**Item 4.****Section 4.55 Application: 65-77 Market St, Sydney - D/2017/167/A**

File No.: D/2017/167/A

**Proposal Summary:** The application is a Section 4.55(2) modification to amend a Stage 1 consent for a mixed-use building comprising retail and commercial uses within the existing 10-storey building with the proposed 22-storey tower form above accommodating residential apartments. The application seeks consent to amend the approved building envelope.

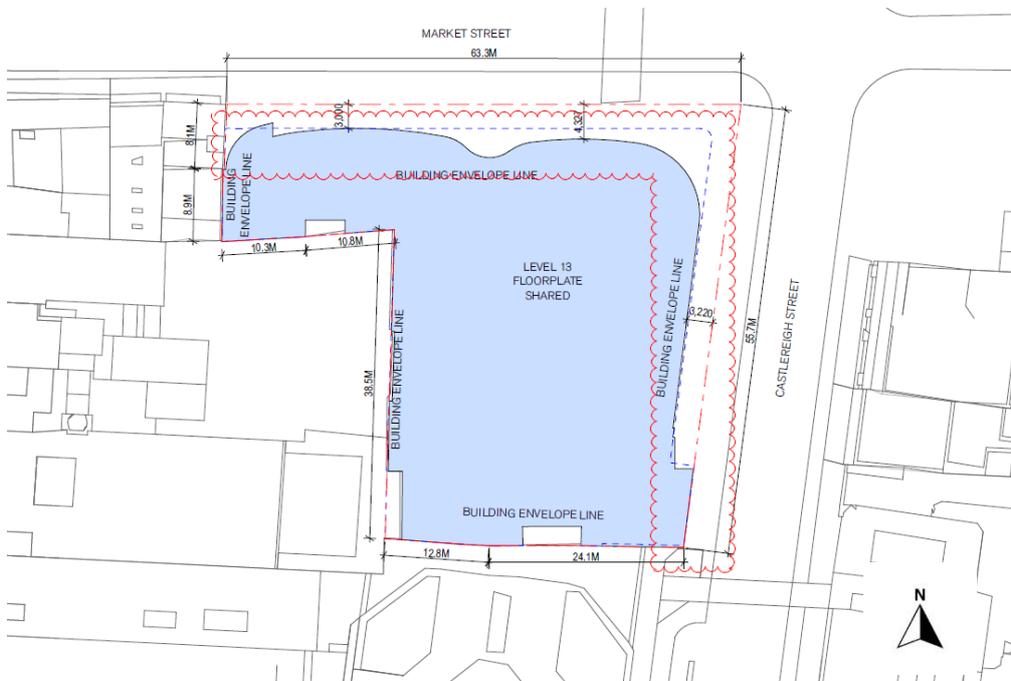
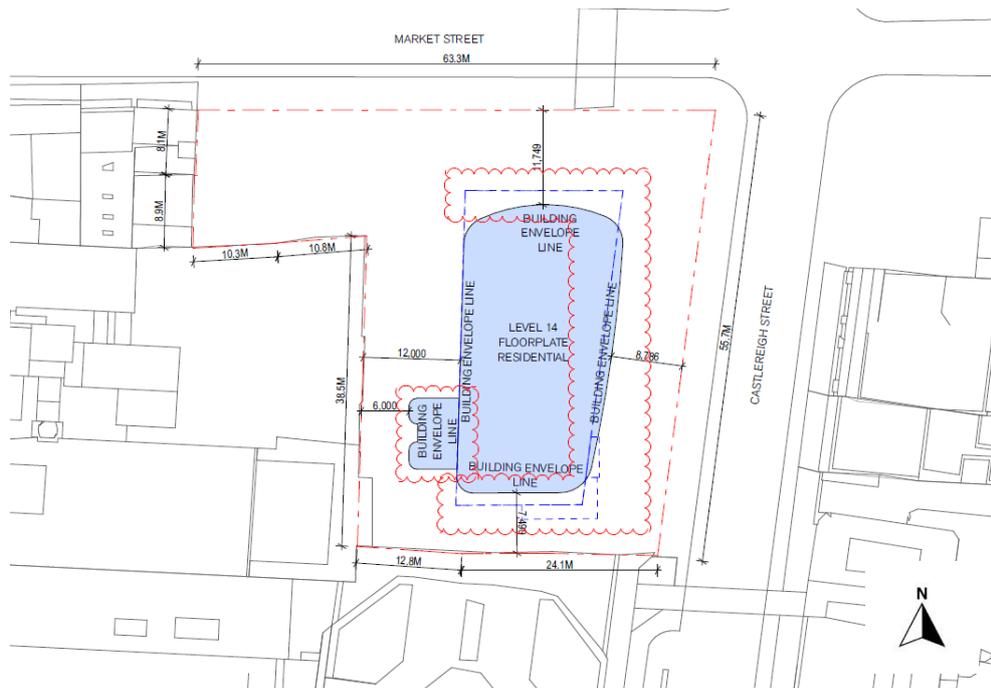
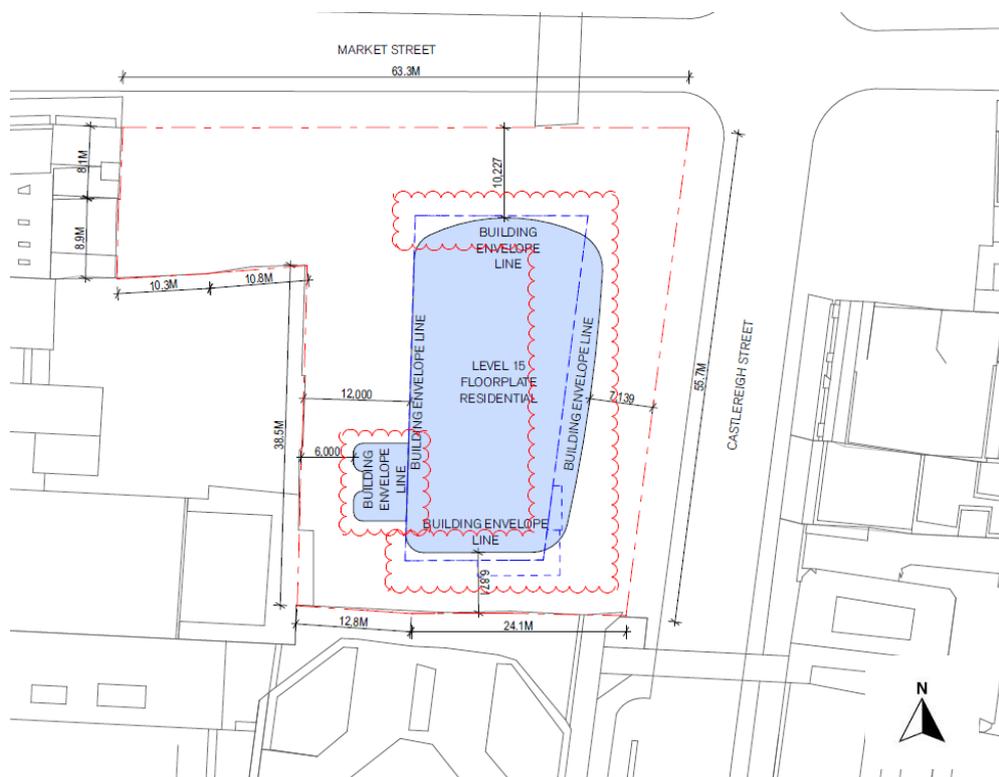
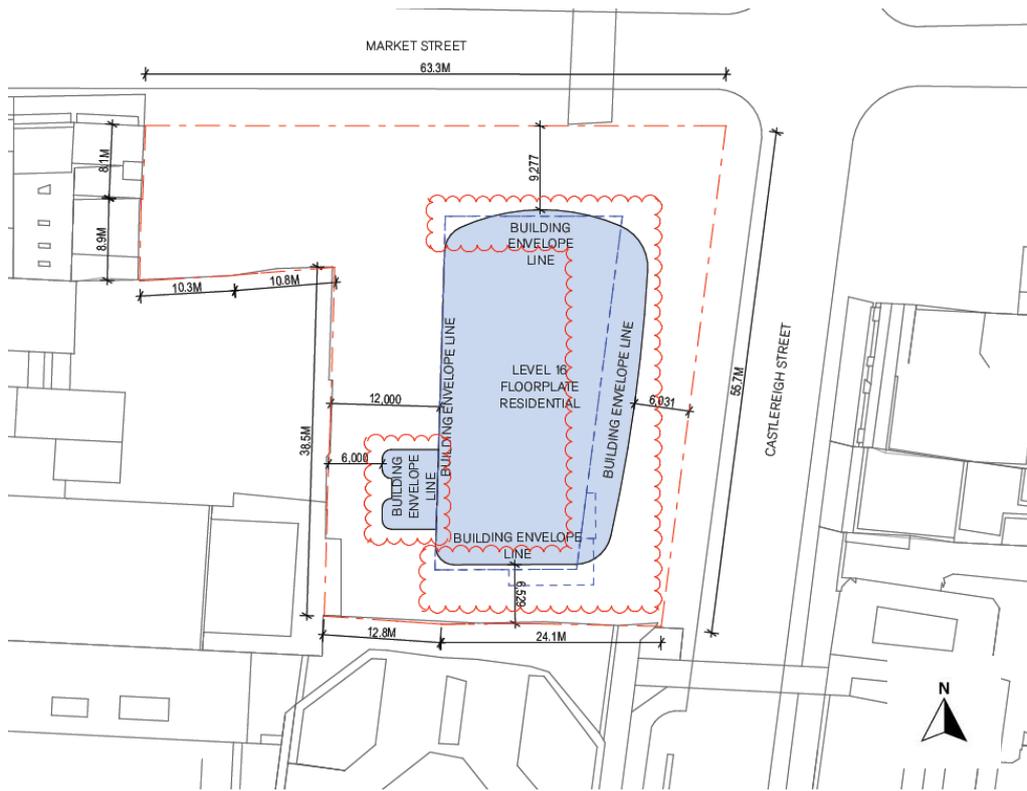
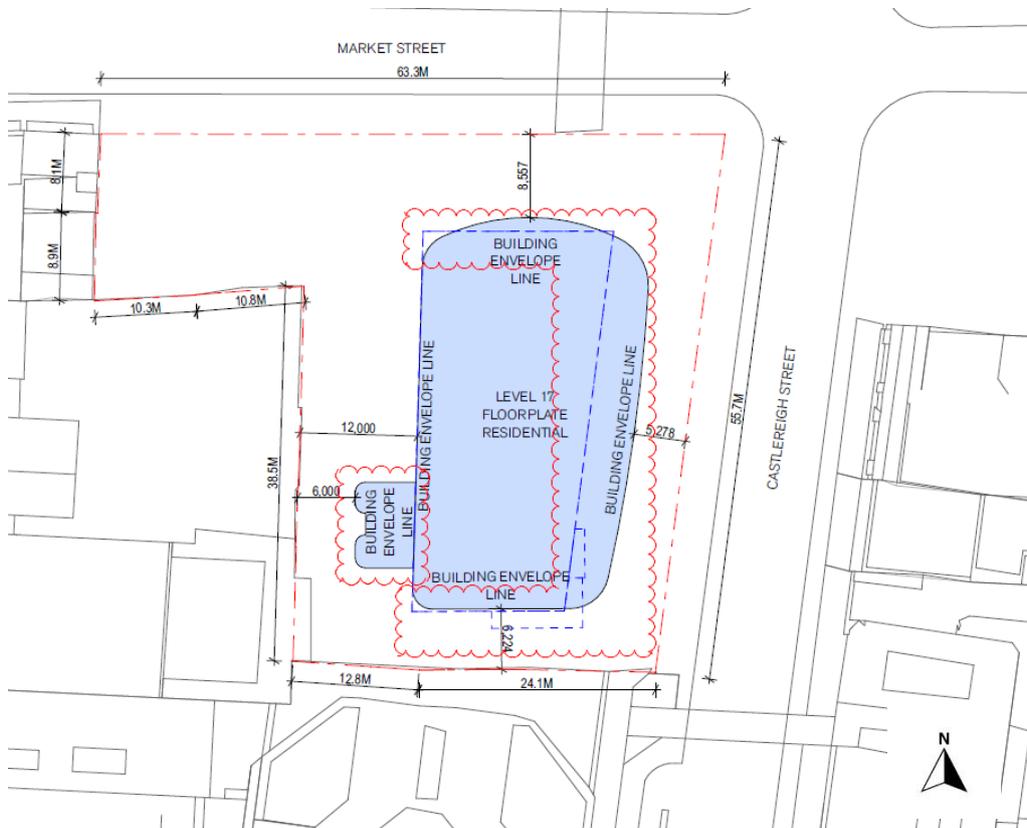
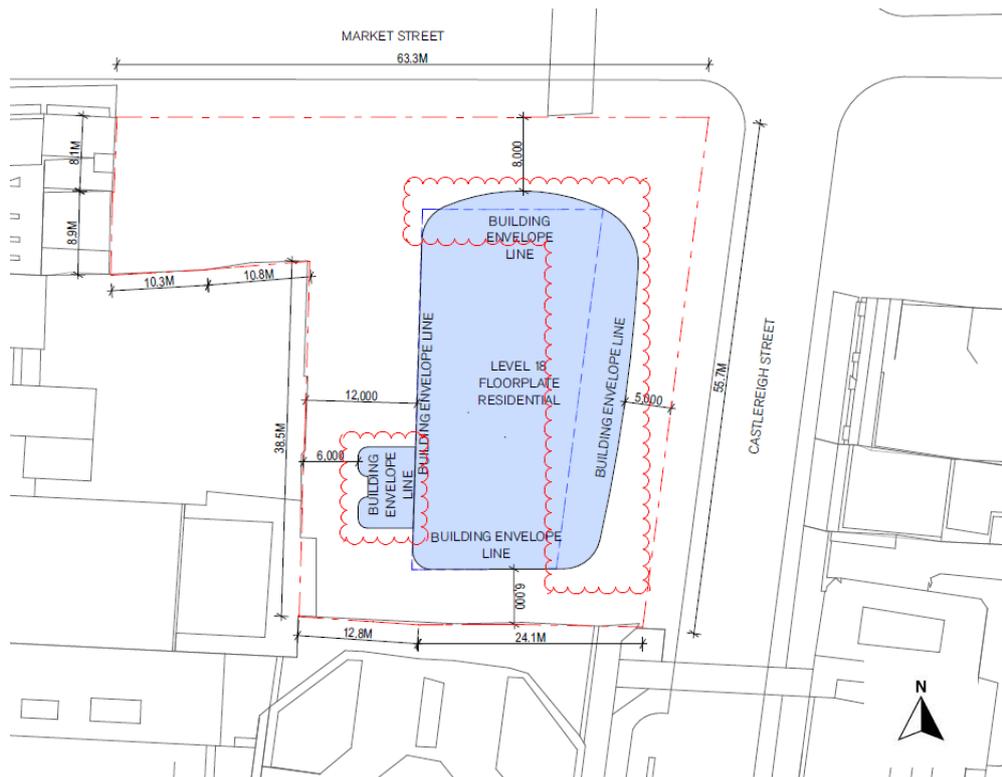
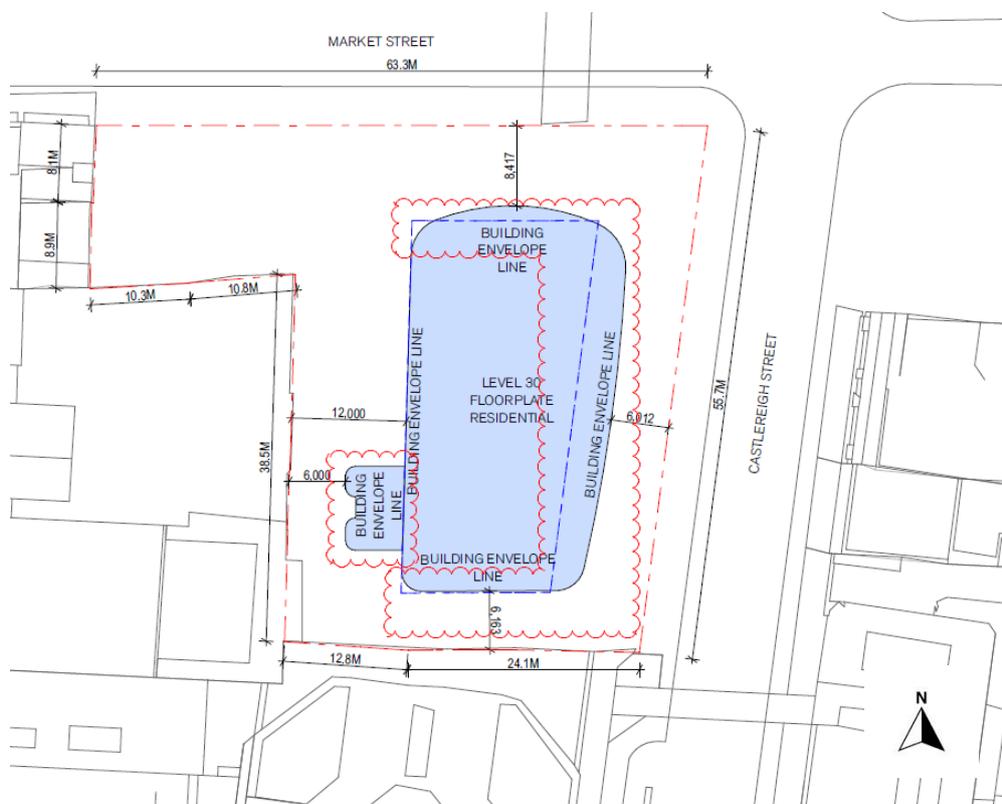
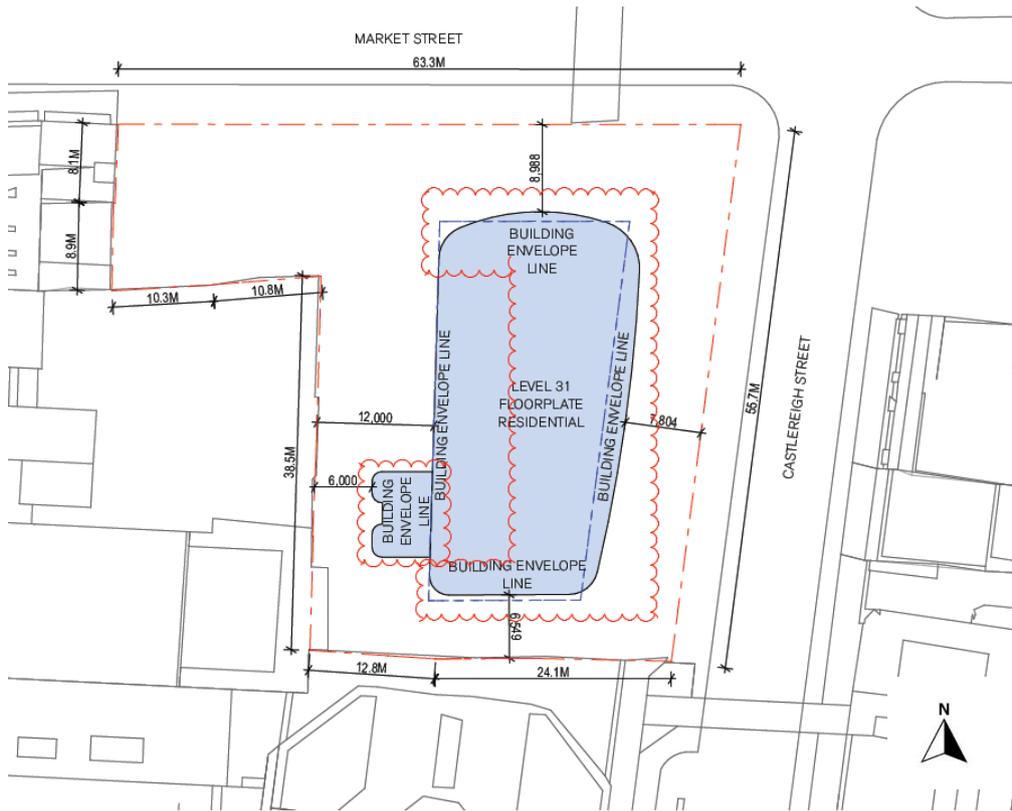
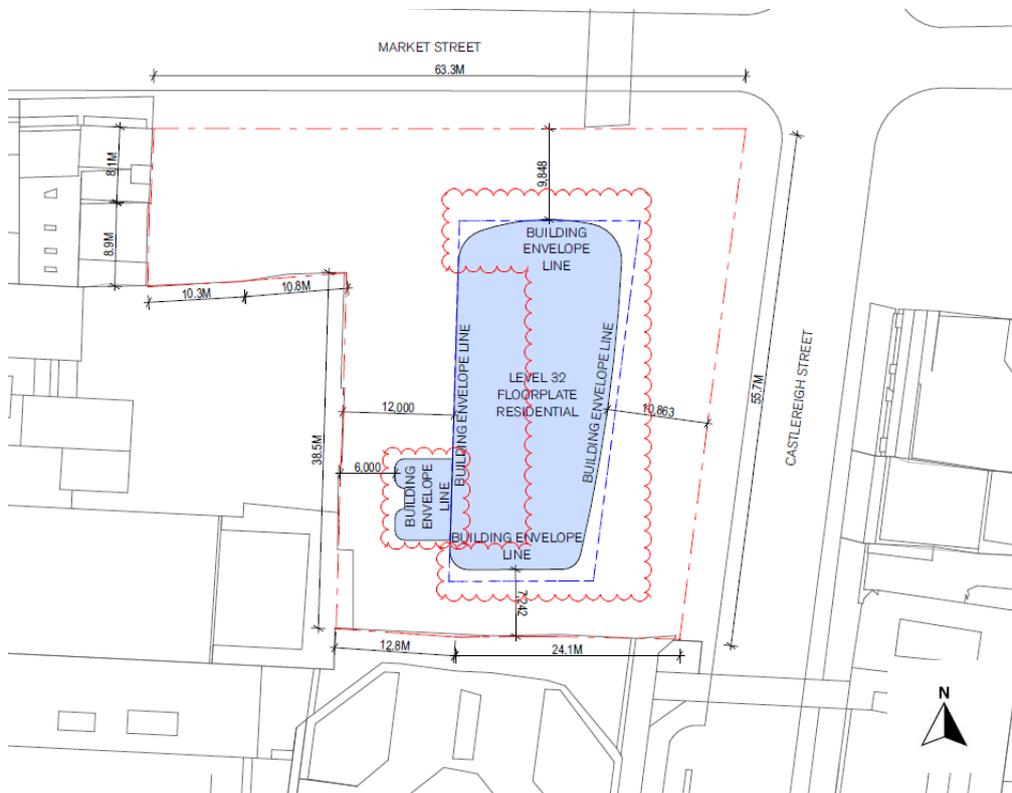
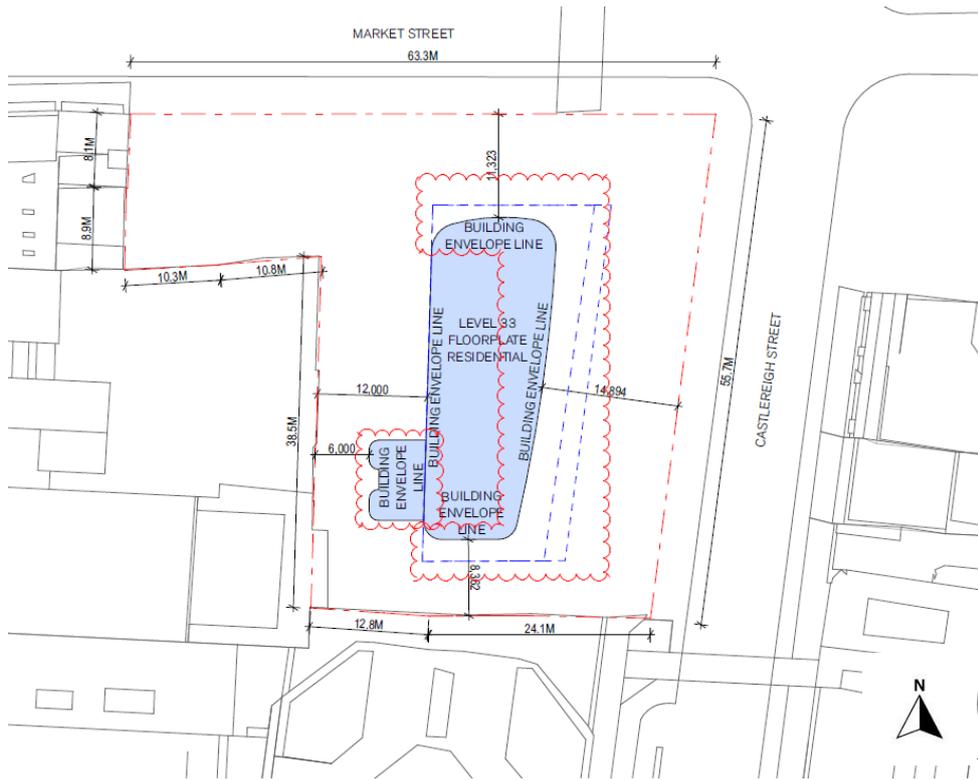
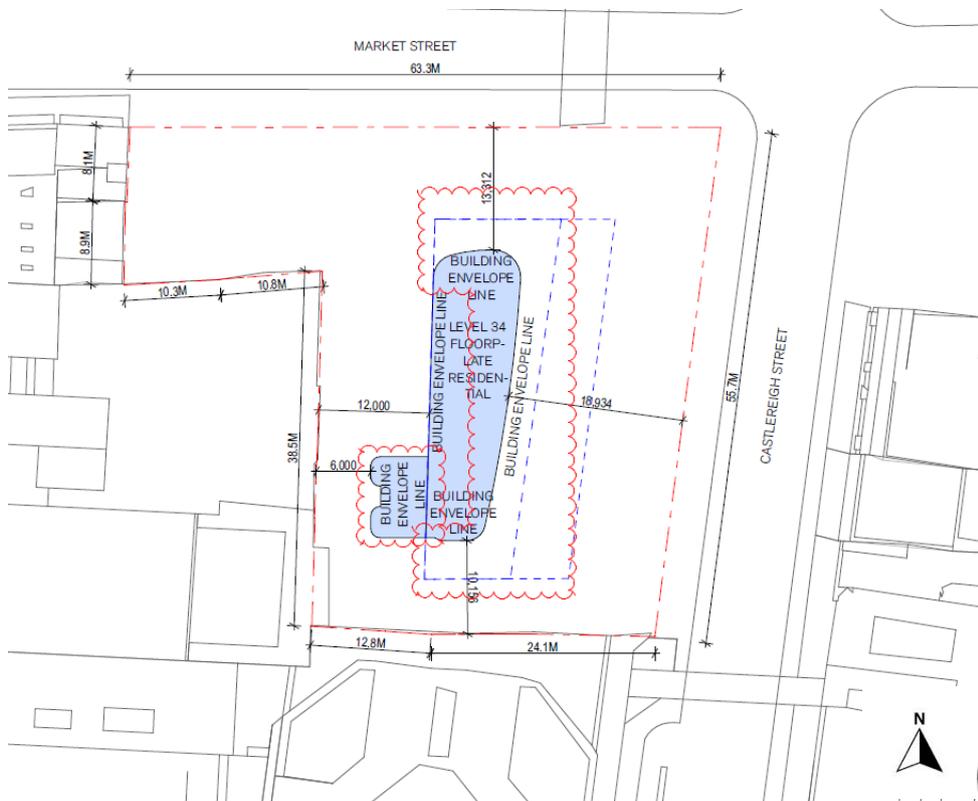
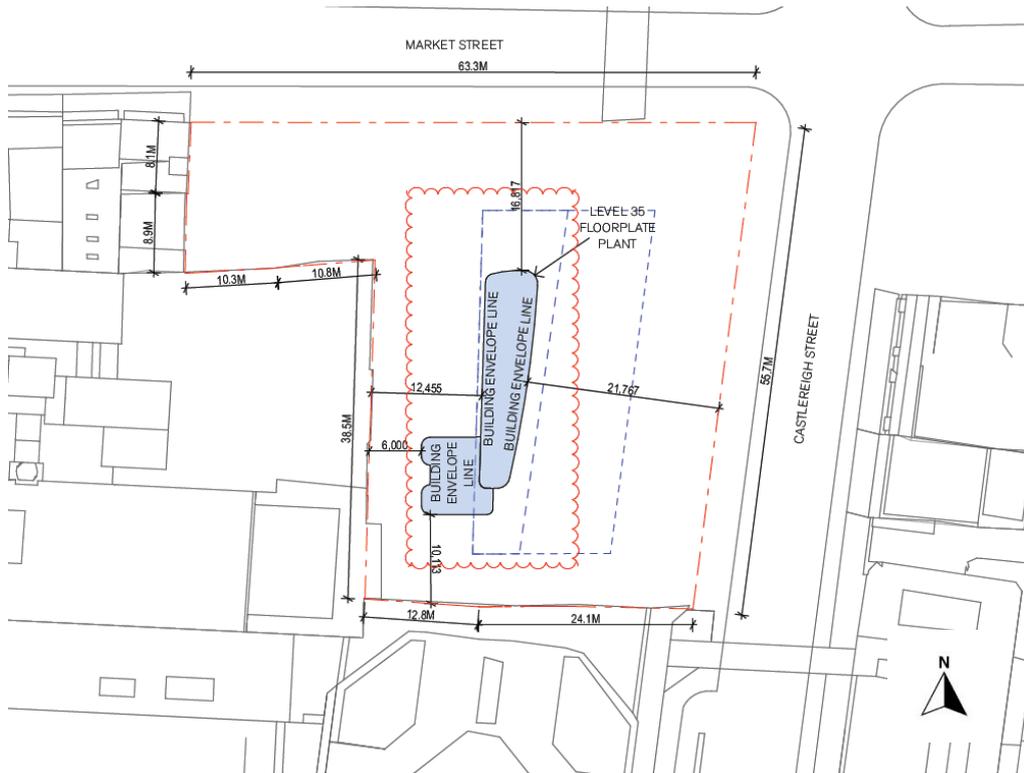
- The modified proposal comprising a curved tower form results in only slight encroachments to the approved setbacks, as shown in Figures 12-24, with the approved setbacks marked in blue on the proposed modified plans.
- The greatest decrease in setback relates to the eastern (Castlereagh Street) setback. This increase will largely not be discernible from the Hilton Sydney, which is located to the south-west of the site.
- The 1m decrease in the minimum setback to Market Street is minor and will not impact on views through to Hyde Park. This minimum setback increases with tower tapering down at the upper and lower points.
- The decrease in setback to the western boundary relates to the lift core only and will likely not be seen from the public domain or surrounding developments once the mixed-use redevelopment of the City Tattersalls Club is developed.

- The modified proposal comprises a minimum setback of 6m to the southern boundary, which was approved under the original application, however this setback now increases to a maximum of 10.1m at the lower and upper points of the tower. This is an improved outcome.

**Figure 23** - Envelope plan of eastern (Castlereagh Street) elevation.

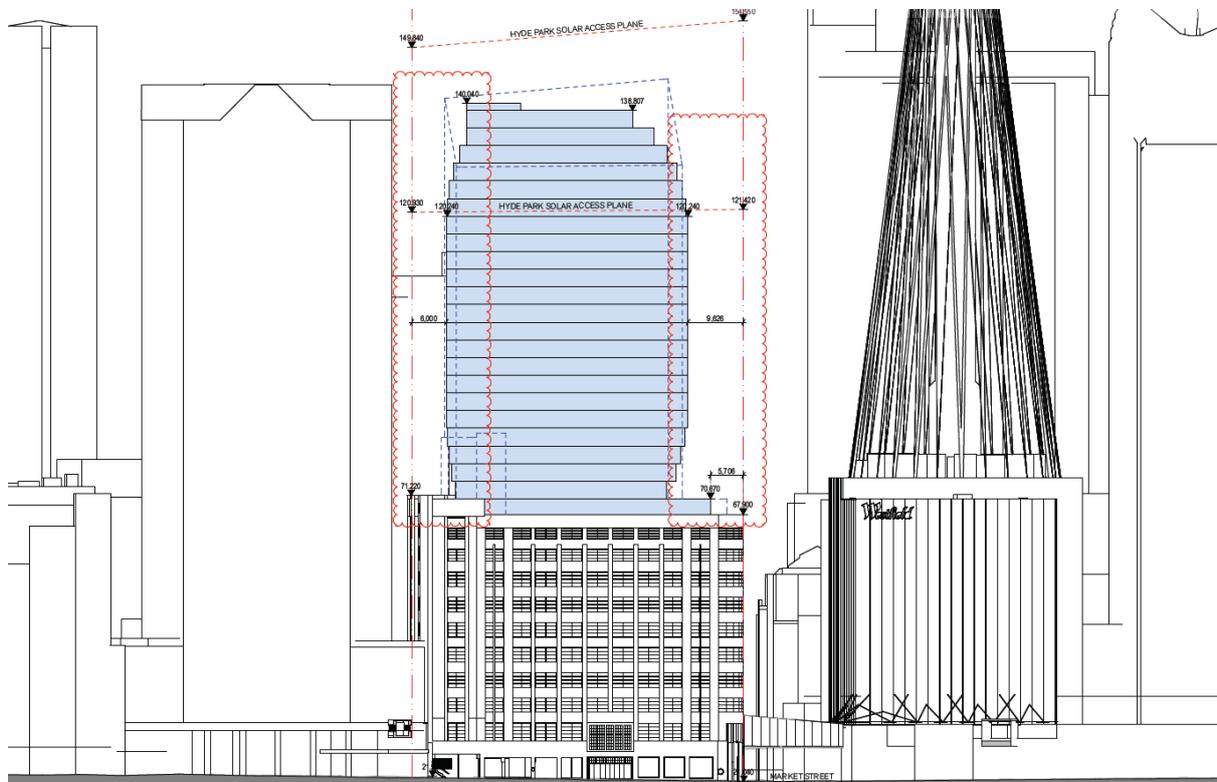
- (b) The proposed tower setback on Castlereagh Street is acceptable taking into account the adjacent conditions.
  - (c) The building separation of 6m is acceptable if privacy issues are addressed as per the approved Stage 1 DA condition for 'non-principle windows or solid wall to southern elevation'. This will require replanning of the impacted apartments and possible modelling of the building envelope.

- (b) Decrease the minimum tower setback on the eastern elevation to Castlereagh Street from 10m to 5m;
  - (c) Decrease the tower setback on part of the western elevation from 12m to 6m to accommodate the external lift core;
